APPLICATION NO.	FILING DATE	FIRST NAMED INVENTOR	ATTORNEY DOCKET NO.	CONFIRMATION NO.
10/762,772	01/22/2004	Stephen W. Briggs III	BBMED.004A	3108

Office Action Summary

DETAILED ACTION

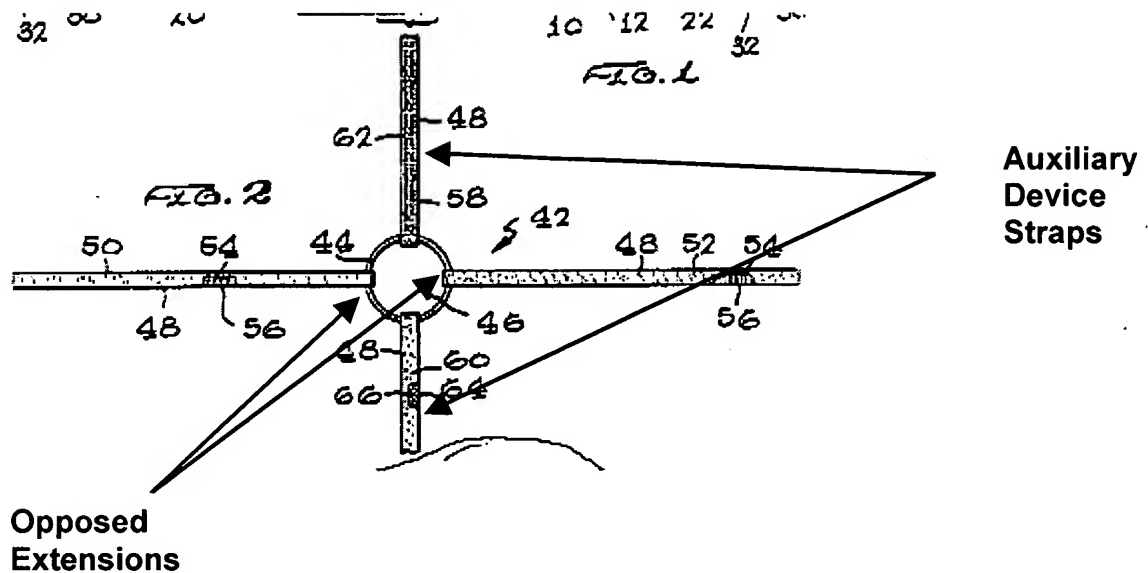
- a ring (44) having a pair of opposed extensions defining strap holds (Col. 3, lines 36-48), and further having a pair of secondary strap holds (see illustration of Fig. 2 below); a void (46) within the ring (44) configured to allow passage of a tracheostomy tube (38) through the ring (44);
- a pair of auxiliary device straps (see illustration of Fig. 2 below) affixed to each of the secondary strap holds, the auxiliary straps configured so that when the tracheostomy tube extends through the ring void (46), the auxiliary straps extend around an auxiliary device (40) that is fit onto the tracheostomy tube (Fig. 5) so as to maintain a maximum spatial relationship between the auxiliary device and the ring (44).
